**PCN# : P57AAAB**  
**Issue Date : Jul. 20, 2015**

**Information Only Notification**

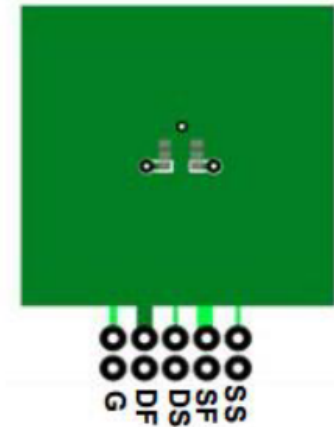
Description of Change (From) :  
Old thermal board images in datasheet (Page 2)

New thermal board images in datasheet (Page 2)

Update thermal board images to match the board used in test.
